Chino Basin Optimum Basin Management Program

Initial State of the Basin Report

Final

RESPONSE TO COMMENTS

Figure 3-5

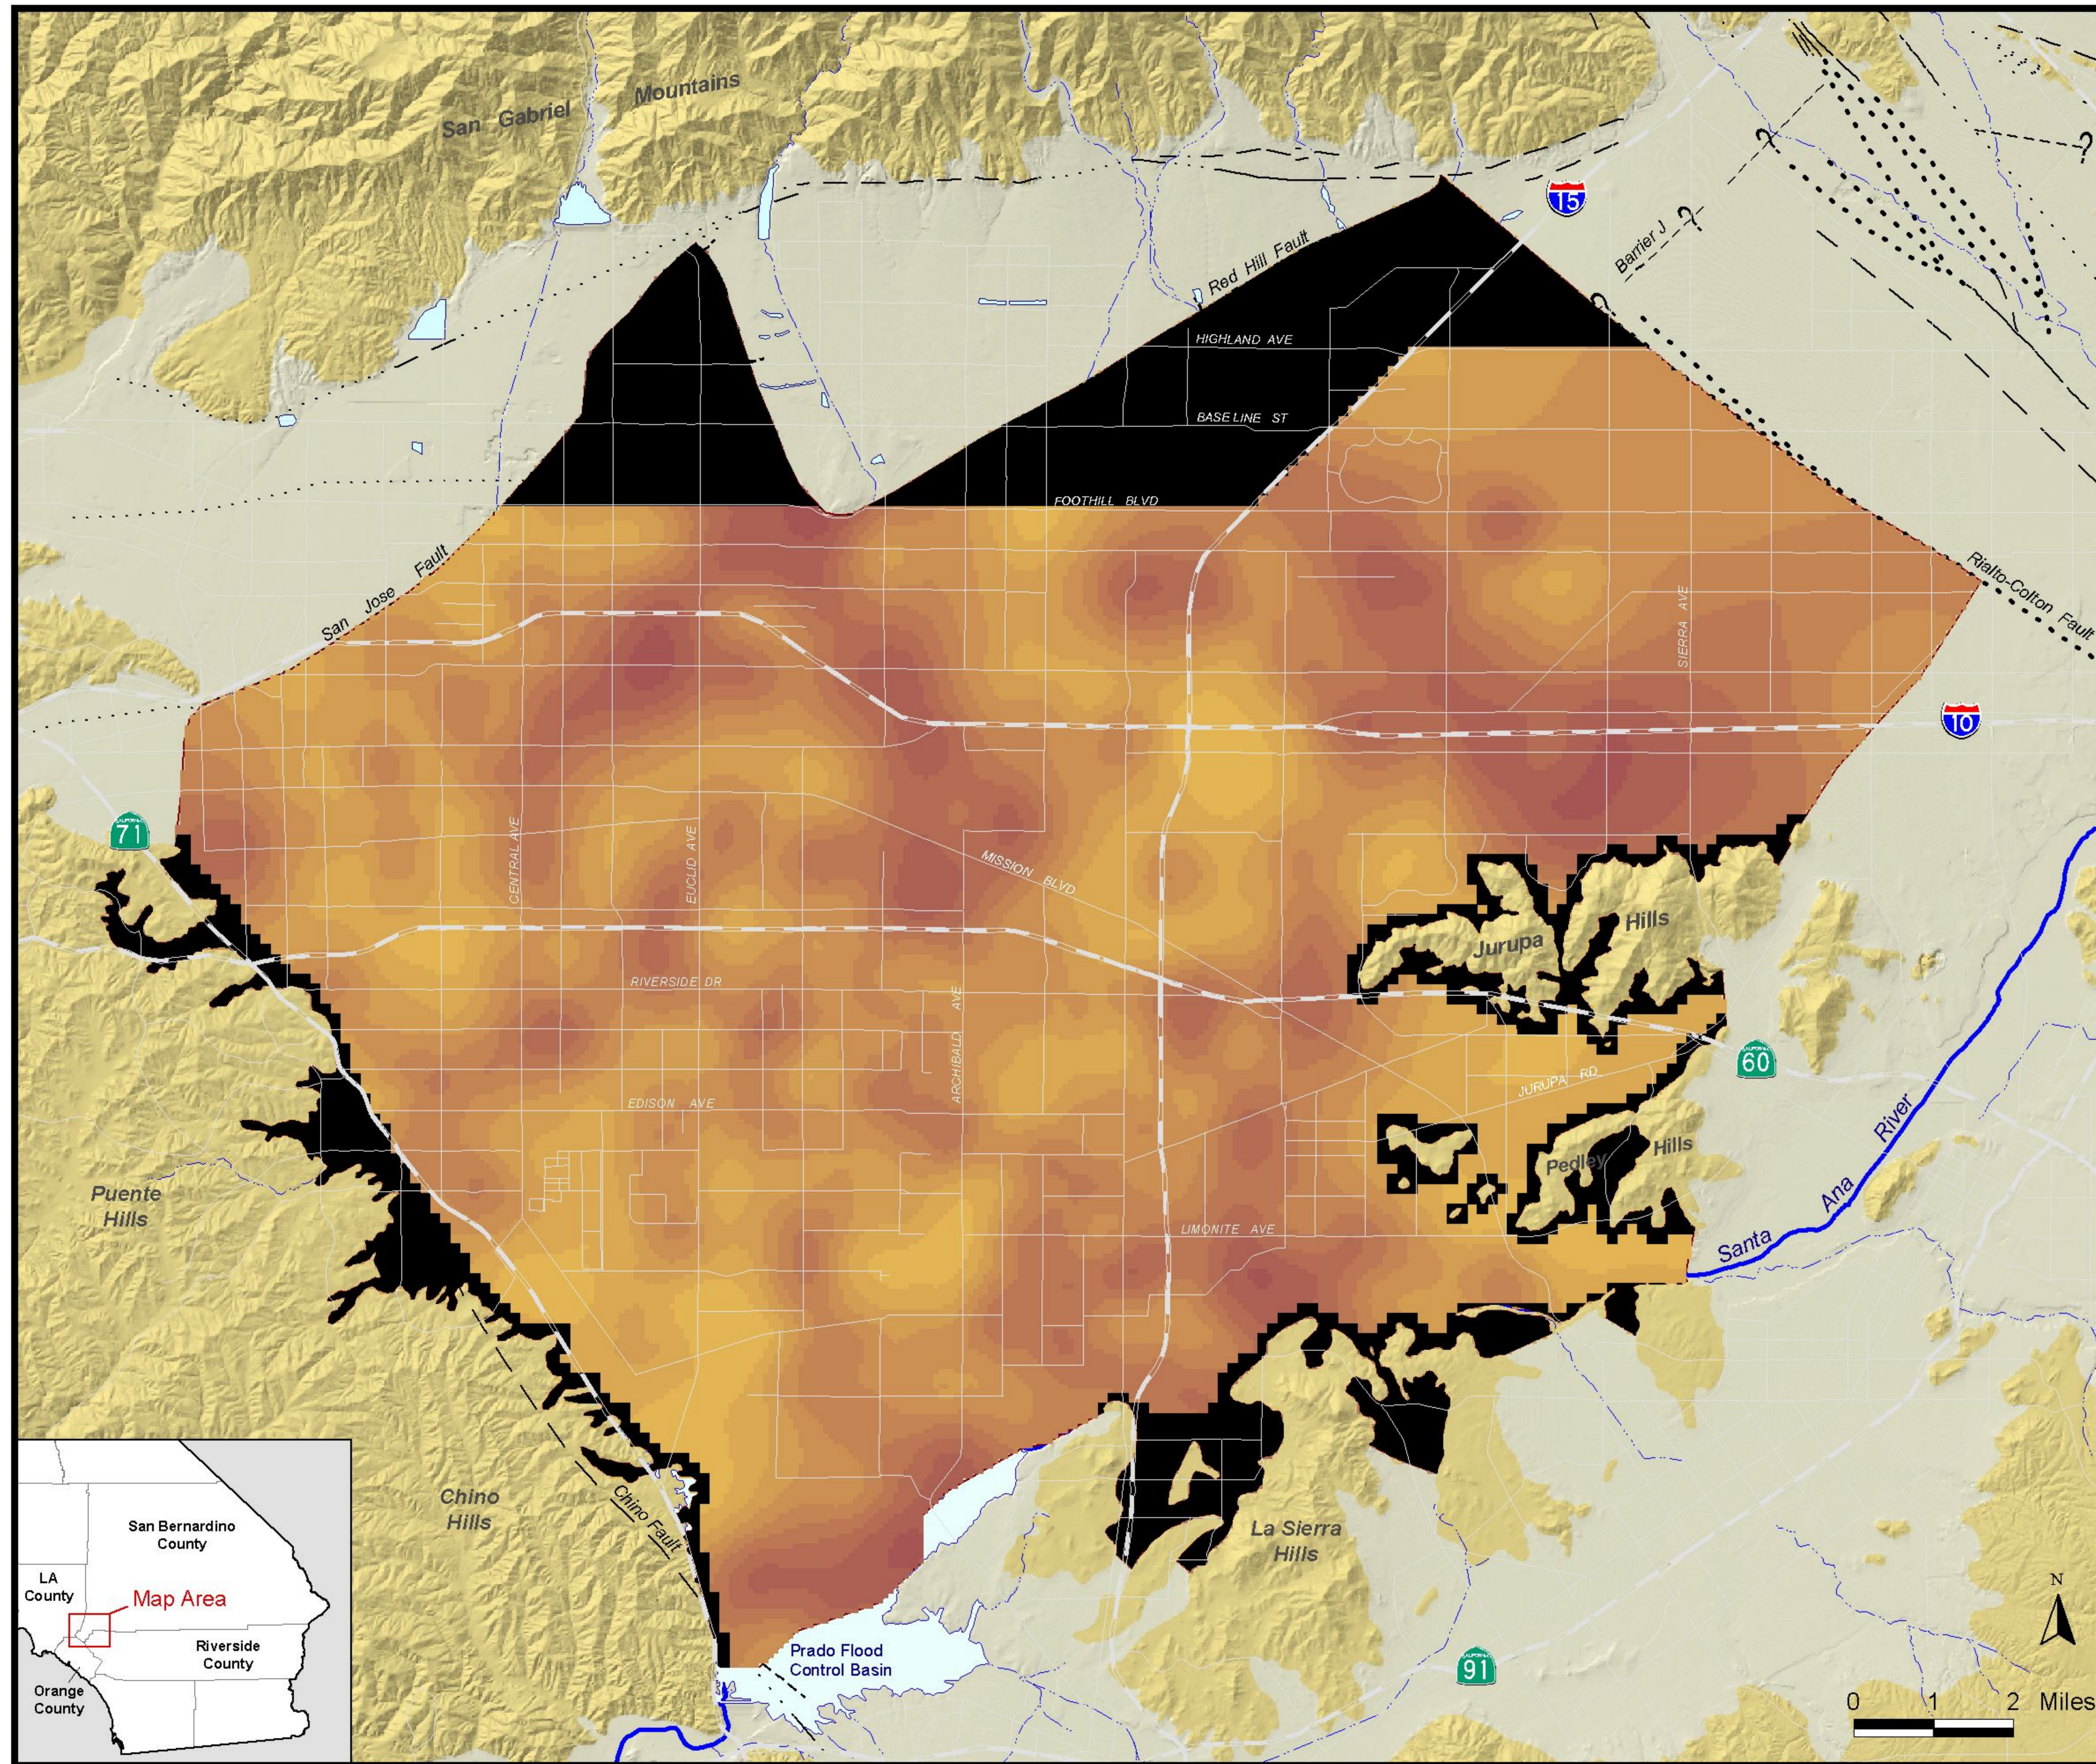
c	Fig 3-5 somewhat implies, by itself, that specific yield changed over time, rather than what was intended (to depict the specific yield of the sediments where water levels and storage have changed).	Comment noted and the figure title was changed to remove this ambiguity.

Figure 4-9

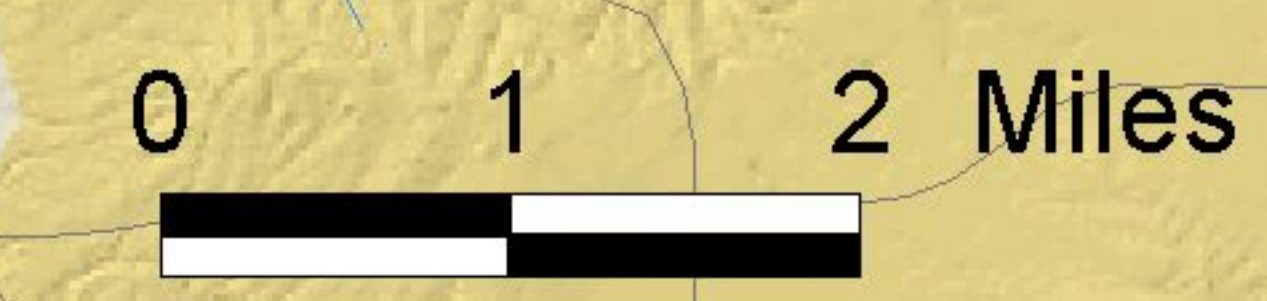
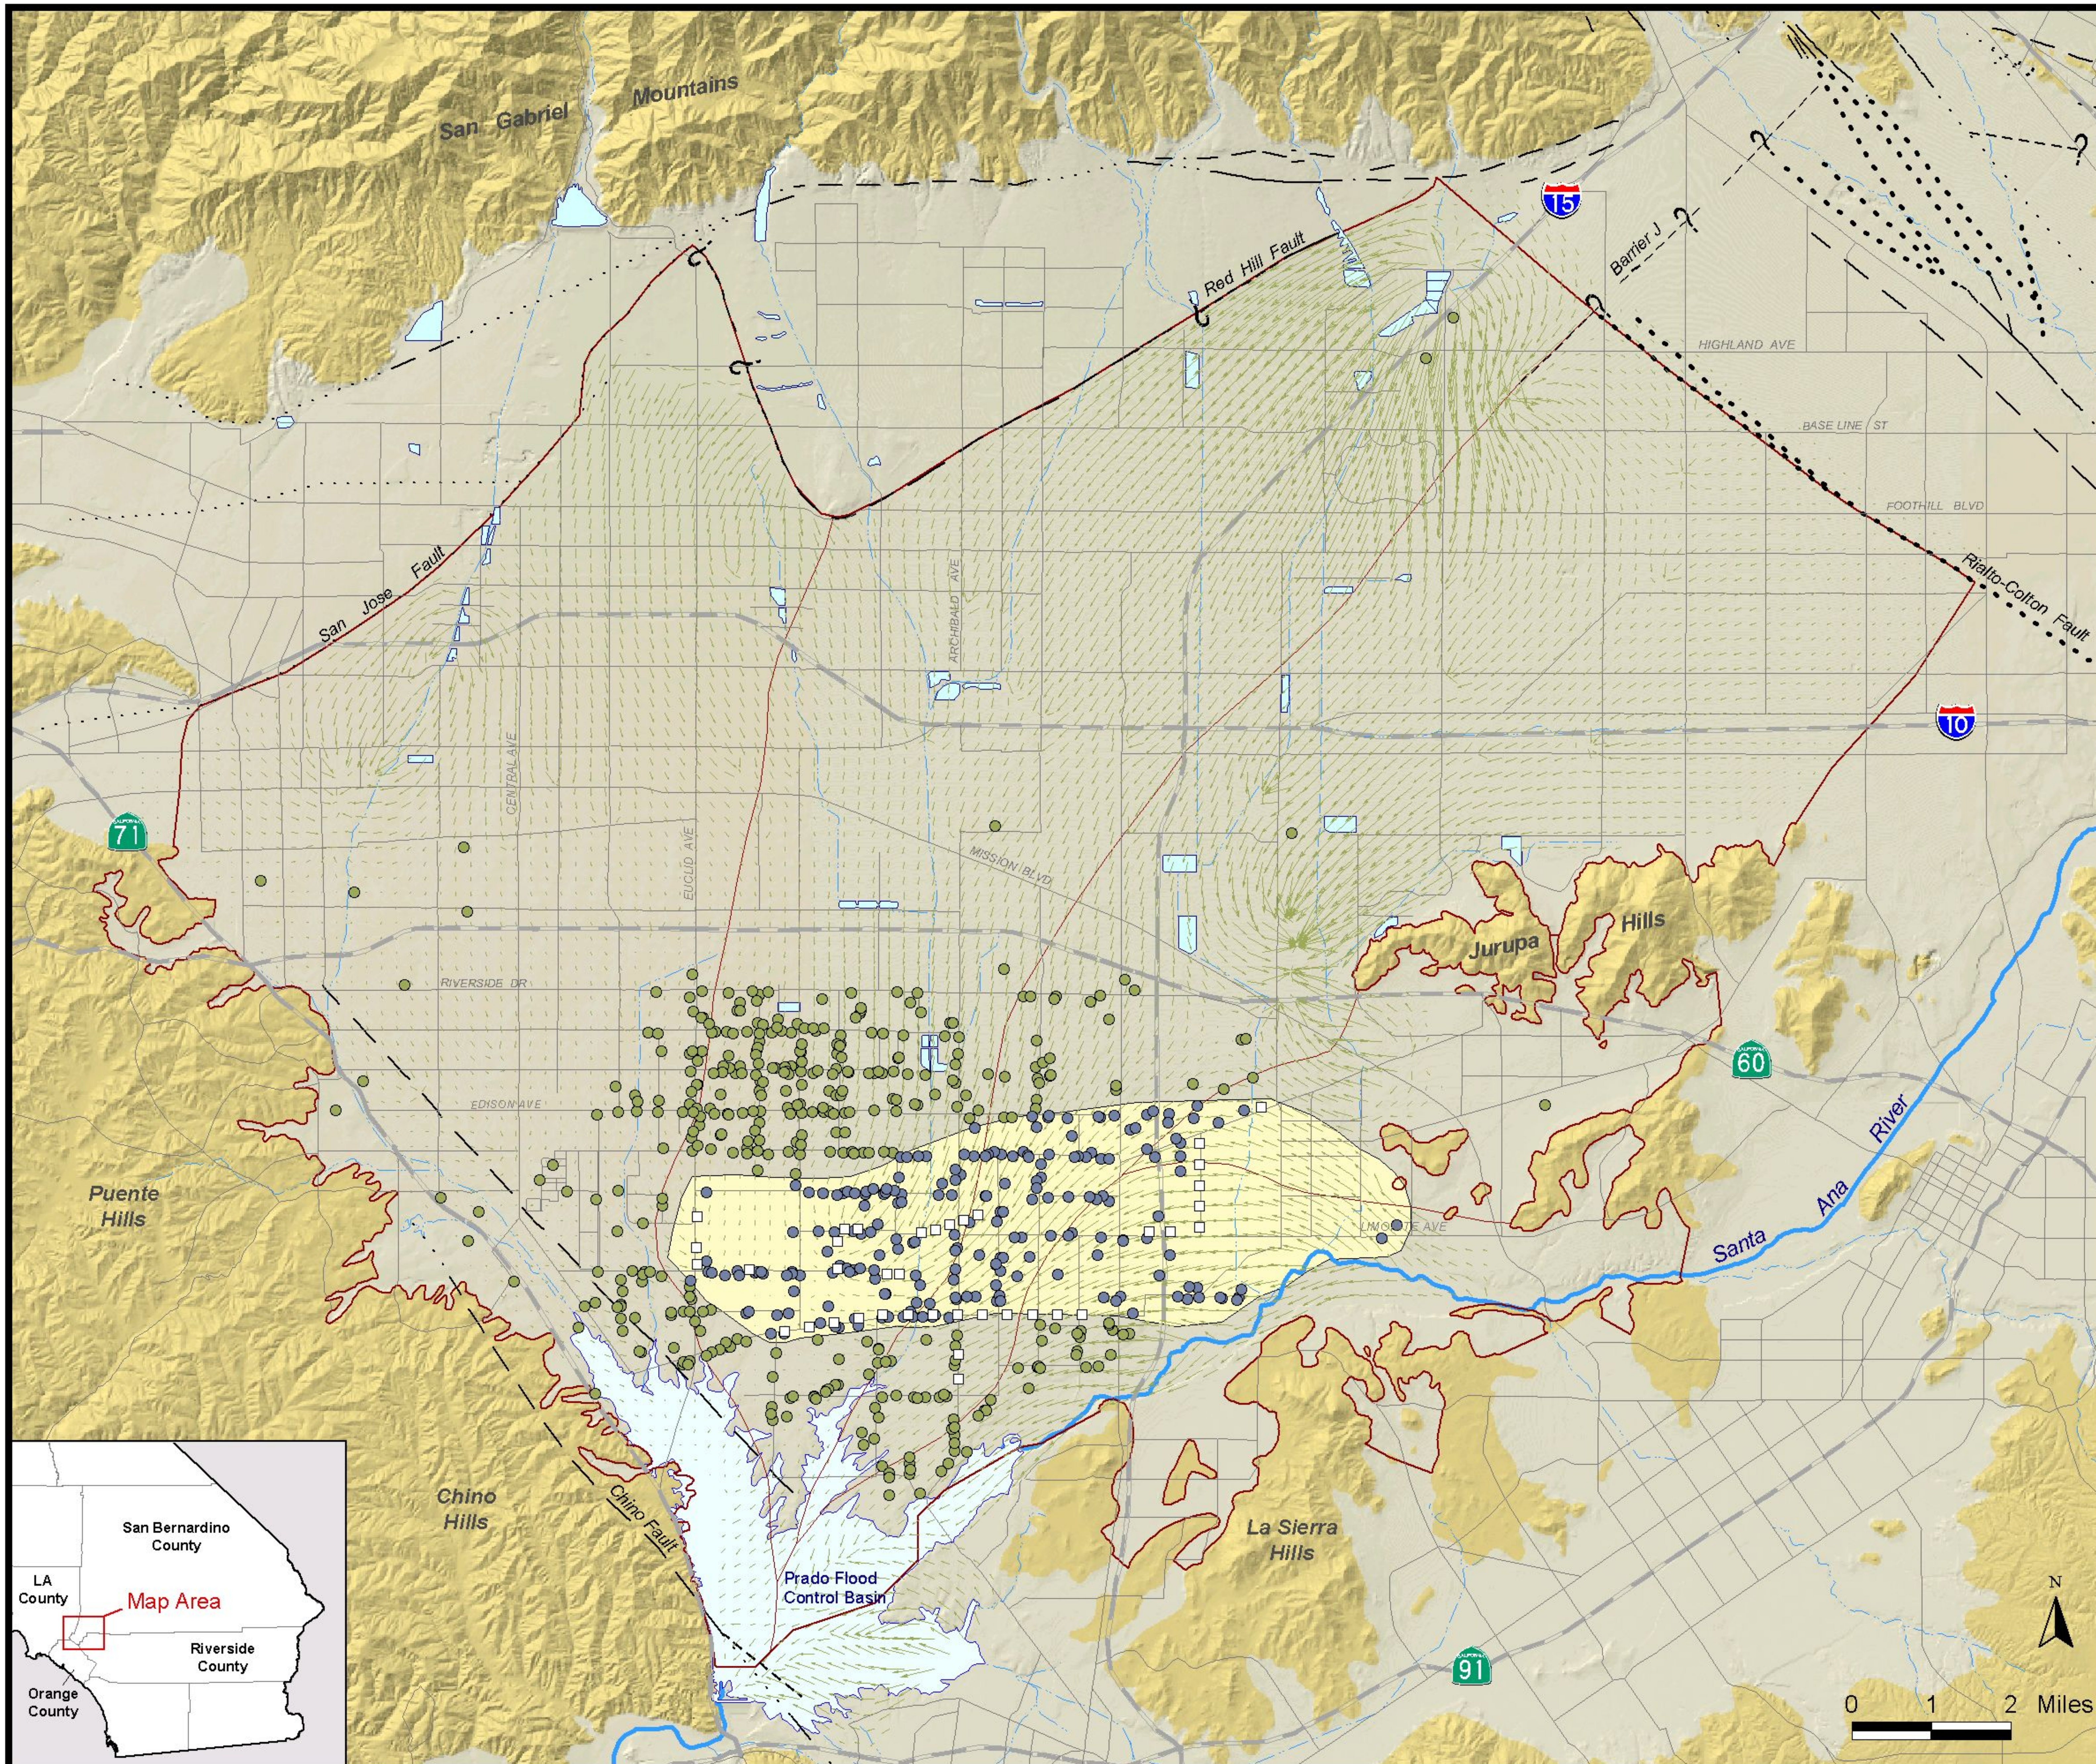
c	Figures 4-2 through 4-7 have convenient break points that coincide with drinking water standards (500 & 1,000 mg/l TDS; 10 mg/l NO3-N); it would be useful to reconfigure Figs. 4-8 & 4-9 to have break points at the MCL’s (5 & 13 µg/l for MTBE) and Action Level (4µg/l for perchlorate) respectively.	Figure 4-8 depicts the distribution of TCE in groundwater in Chino Basin and the class intervals were selected based on its MCL of 5 µg/L. The class intervals for Figure 4-9 have been modified to reflect the revised Action Level for perchlorate. A map was not produced showing the distribution of MTBE, because only two wells had detectable concentrations of this contaminant.
